East Anglia ONE North and East Anglia TWO Offshore Windfarms

Applicants' Comments on SASES' Deadline 4 Submissions

Applicant: East Anglia TWO and East Anglia ONE North Limited
Document Reference: ExA.AS-9.D5.V1
SPR Reference: EA1N_EA2-DWF-ENV-REP-IBR-001223

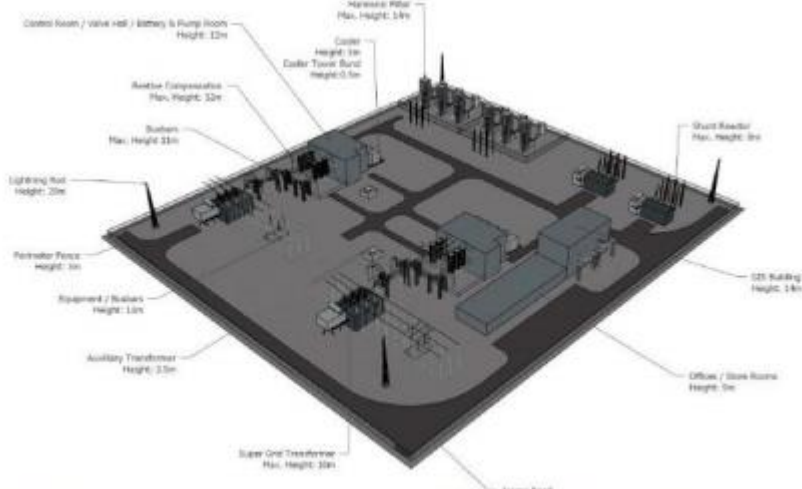
3	<p>4. The 3D schematic (Plate 5.2 of [REP3-057]) and revised OLMP (Figure 3 of [REP3-030]) both show large areas of vacant substation area between the reduced sized electrical equipment. The Applicants are asked to justify why the equipment spacing is so great and why there is no reduction in the 190m dimension. It should be noticed that the orientation of the 3D schematic in plate 5.2 is different from the orientation of both the eastern and western substation shown in the OLMP.</p>	<p>A comparative assessment of the Projects' substation design envelopes with that of the already constructed East Anglia ONE project was used to determine a preliminary, worst-case onshore substation footprint. This was further refined through conceptual electrical design (power systems) studies that were carried out to determine key reference parameters to guide the onshore substation concept sizes. The studies were based typically on assumed component parameters, early stage supplier engagement information and experience gained from similar projects, in order to form the onshore substation conceptual design envelope of 190m x170m.</p>

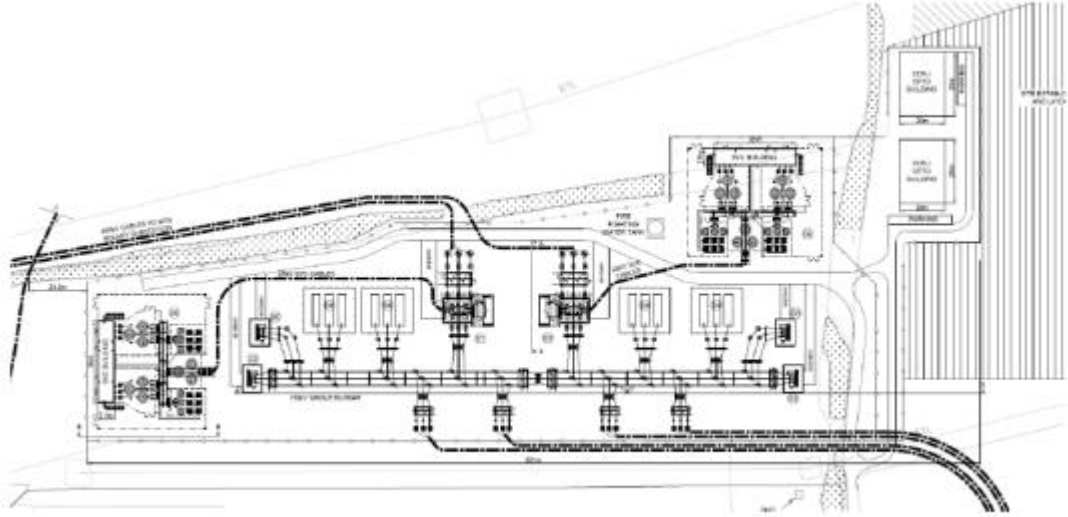
ID	Written Representation	Applicants' Comments
		further minimise the environmental impacts of the Projects.
6	7. The reference Rampion wind farm substation design (Figure 3 on page 165 of [REP1- 227]) appears to use multiple smaller Harmonic Filters in order to produce an overall reduction in height. Has this option been explored?	<p>The Applicants refer to section 6.2 of the Substations Design Principles Statement submitted at Deadline 4 (REP4-029). A 4m reduction in the height of the harmonic filters has been achieved.</p> <p>The Applicants will progress its procurement and detailed design process in due course and will consider viable solutions for the onshore substation within the permitted extent of the Projects' DCOs and in doing so will seek to further minimise the environmental impacts of the Projects.</p>
7	8. There is not thought to be any specific reason why the substation footprint has to be rectangular. The footprint of the reference Rampion wind farm substation (Figure 3 on page 165 of [REP1-227] and reproduced below) is not rectangular; rather it has been designed to fit within existing site hedgerow boundaries, so avoiding unnecessary environmental destruction and maximum use of existing screening. Have the Applicants given consideration to this approach?	<p>Rectangular substations are the standard approach, which leads to certain benefits in utilising efficiently the space within the substation compound (in terms of equipment siting, cables laying and relevant safety clearances).</p> <p>The Applicants refer to their response provided at ID3 of this table with reference to their responses to Examining Authority's Written Questions Volume 2 – 1.0 Overarching, general and cross-topic questions (REP1-105). Minimum spacings are required for safe and efficient construction and operation.</p>

ID	Written Representation	Applicants' Comments
	 <p data-bbox="264 863 376 895">Figure 3</p>	
8	<p data-bbox="264 932 1442 1102">9. Landscape design and ‘micro-siting’ with a further reduced substation footprint together with the GIS version of the proposed NGET substation could allow a much reduced landtake for the project, and some potential layouts on this basis might allow retention of the ‘Pilgrim’s Way’ north-south footpath. The current proposals are regarded as unacceptable over-development of a greenfield site and contrary to the policy requirements of good design.</p>	<p data-bbox="1496 932 2051 1174">The Applicants refer to their responses provided to Q1.0.5 and Q1.0.12 of Examining Authority’s Written Questions Volume 2 – 1.0 Overarching, general and cross-topic questions (REP1-105) regarding land take and the need for AIS at the National Grid substation and Q1.0.1b regarding good design.</p>
